# Access Compliance Report

## Public Rights-of-Way

Intersection ID: 51511	Main Street: PEARL_PARK_WY	Cross Street: S_KINGS_DR	Location: NW
ADA ID: 773F29CE5E43	Ramp Type: Perp	Initial Pass/Fail: Fail	Overall Compliance: No
Severity Score: 8.75			
Codes/Mitigation Info/Possible Solution		Field Measurements/Component Compliance

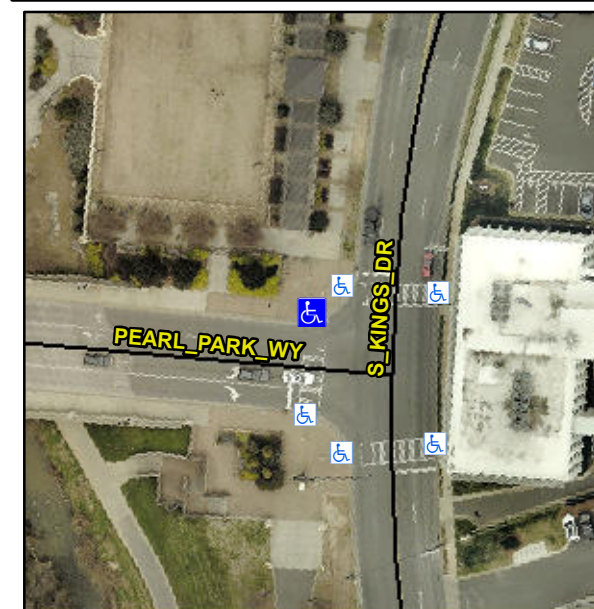
**Not Found, R304.5.1**

Compliance	Description	Data	Compliance	Description	Data
N/A	Ramp Length (in)	48.0	Yes	Ramp Slope (%)	6.7
No	Ramp Width (in)	45.0	Yes	Ramp XSlope (%)	0.4
N/A	Flare Type LT	N/A	N/A	Flare Type RT	N/A
N/A	Flare Slope LT (%)	N/A	N/A	Flare Slope RT (%)	N/A
N/A	Flare Traversable LT?	N/A	N/A	Flare Traversable RT?	N/A
N/A	Landing Length (in)	N/A	N/A	DWS Provided?	N/A
N/A	Landing Width (in)	N/A	N/A	DWS Contrast?	N/A
N/A	Landing Slope (%)	N/A	N/A	DWS Length (in)	N/A
N/A	Landing X Slope (%)	N/A	N/A	DWS Full Width?	N/A
N/A	Landing Curb? (Y/N)	N/A	N/A	DWS Offset (in)	N/A
N/A	Shared Landing?	N/A			
N/A	Gutter Ponding?	N/A	N/A	Gutter Slope (%)	N/A
N/A	Gutter Lip Ht (in)	N/A	N/A	Gutter X Slope (%)	N/A
N/A	Painted X Walk1?	Yes	N/A	Painted X Walk2?	N/A
	X Walk 1 Direction	To S		X Walk 2 Direction	N/A
N/A	X Walk 1 Width (in)	118.0	N/A	X Walk 2 Width (in)	N/A
	X Walk 1 Slope (%)	2.7		X Walk 2 Slope (%)	N/A
	X Walk 1 X Slope (%)	2.3		X Walk 2 X Slope (%)	N/A

**Remove & Replace Entire Ramp.**
